RE : SSD-31822612 - Barker College 91 Pacific Highway, Hornsby: 9 & 27-31 Clarke Road and 5 & 7 Marillian Avenue, Waitara and 30A & 32A Unwin Road, Wahroonga

The following comments are provided for consideration and to assist the Department in the assessment of the SSD application.

Figure 19 On Site Pick up/Drop off arrangements

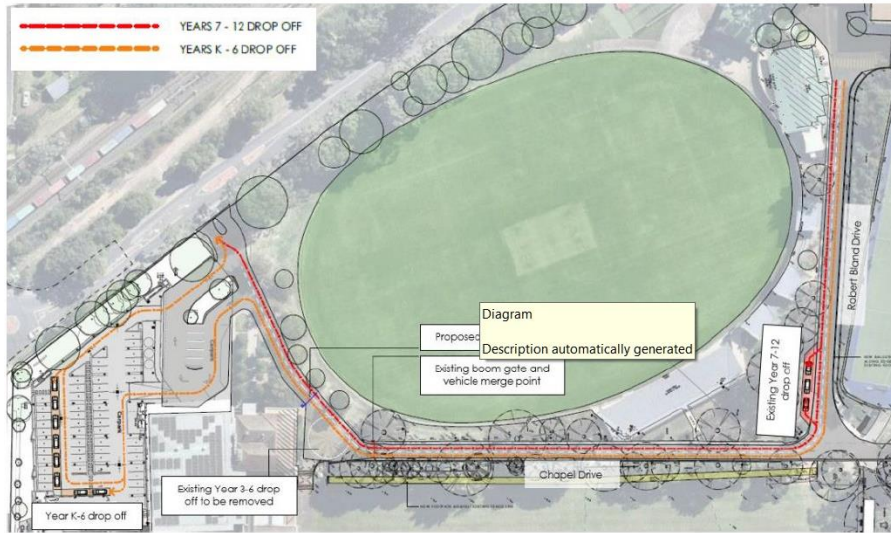
As illustrated in **Figure 19**, the proposed arrangements will result in two ultimate lanes of traffic which will merge at the exit point to College Crescent.

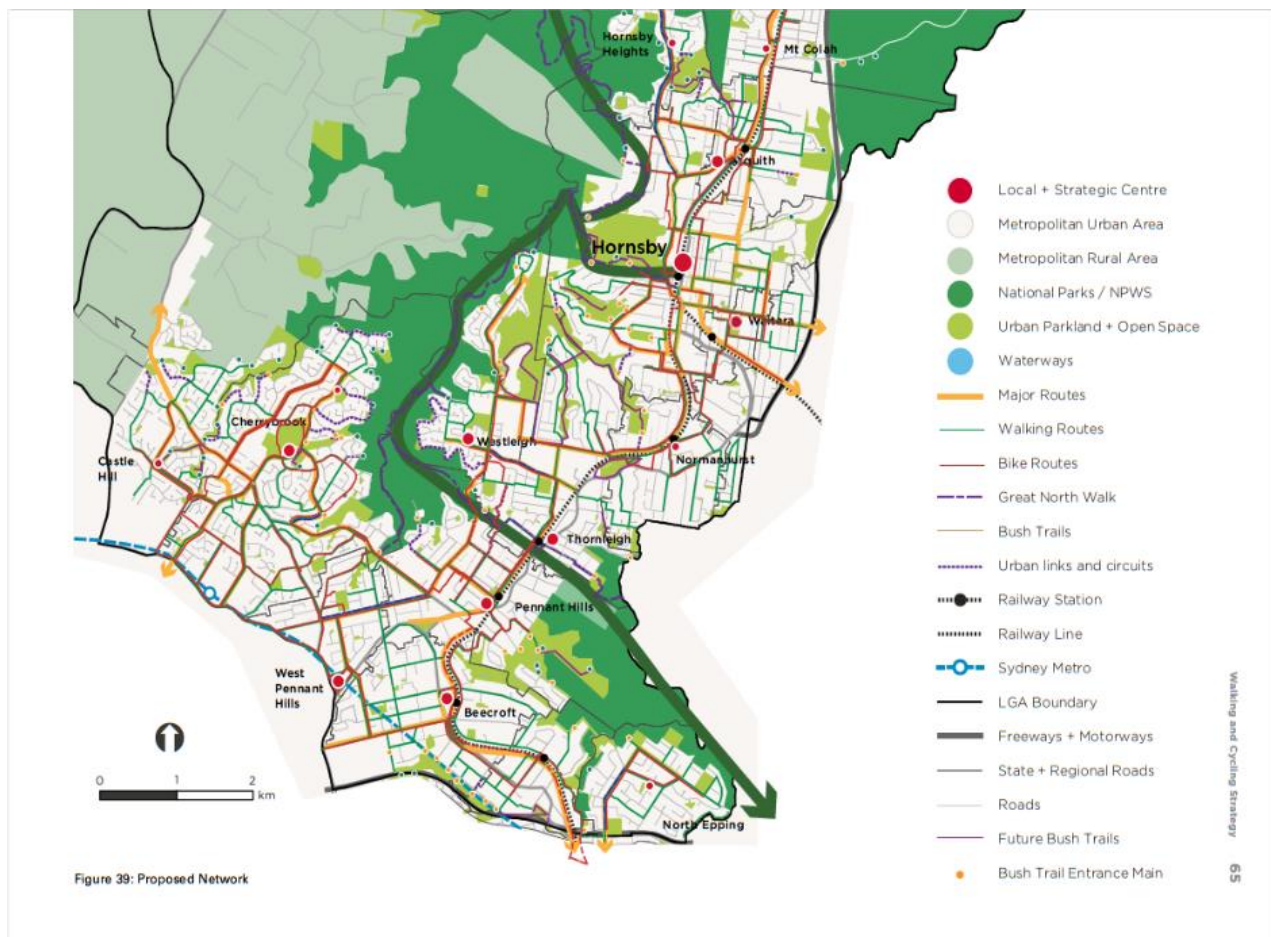
Baker College operating its own bus network. Students use both Baker College and public buses. More detail is required regarding the existing and the impact of additional bus movements to cater for the additional student number and if it can be accommodated in the existing bus zone and ensuring buses are not restricting traffic flow in the area.

2. The traffic report be updated with the data available from the NorthConnex Road Network Performance Review Plan.
3. The applicant to provide a more detail report on the number of students and staff uses buses, number of buses required, the existing capacity and storage. Will the existing Bus Zone be adequate to meet the needs of Barker College.

Figure 2.3: Existing On-Street Parking Restrictions

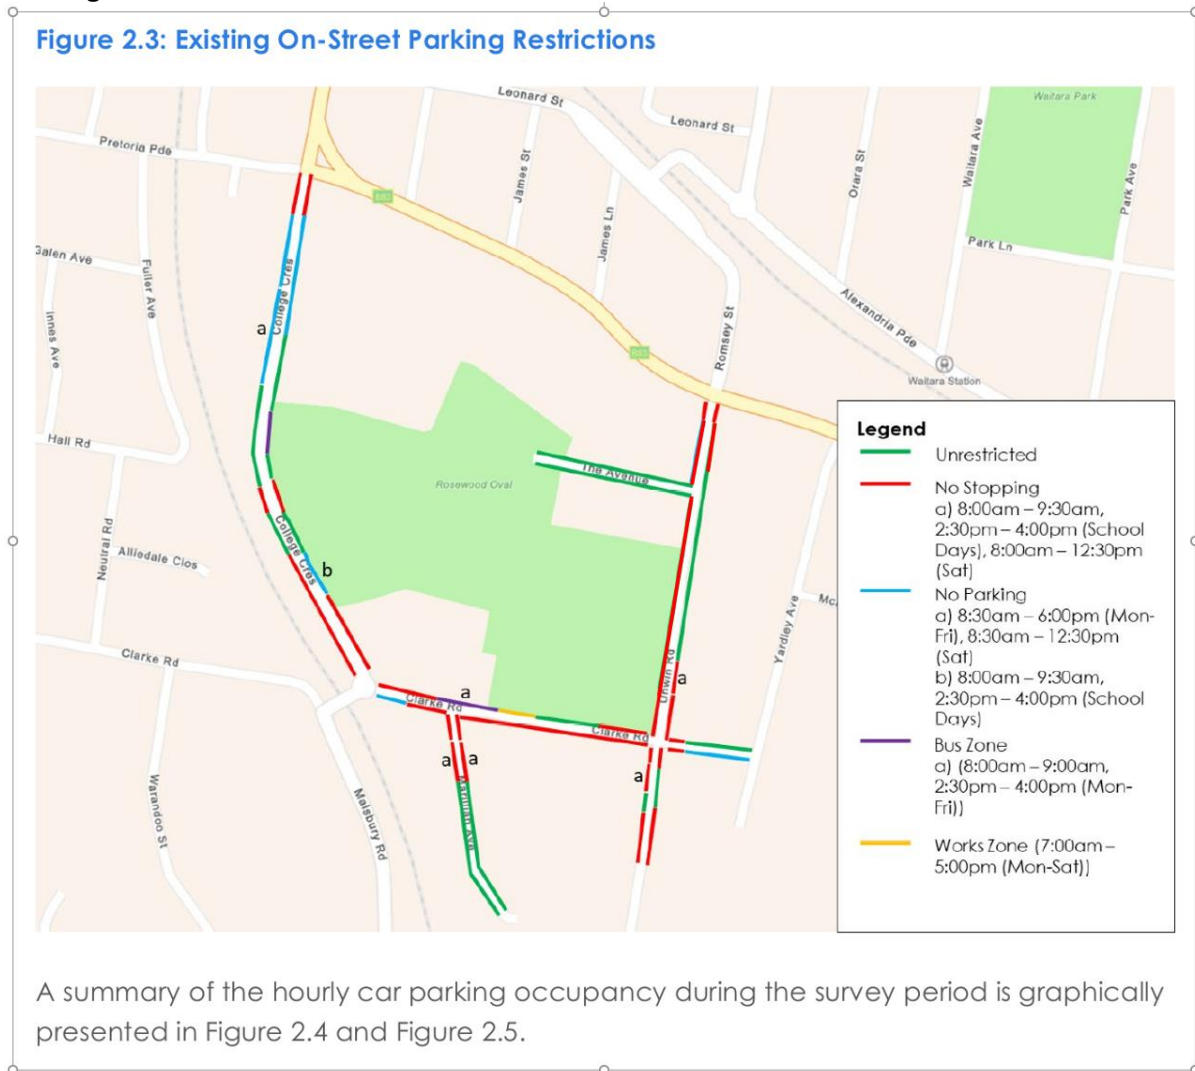
There are only 484 existing carparking spaces available on site. The development will not provide any additional carparking space.
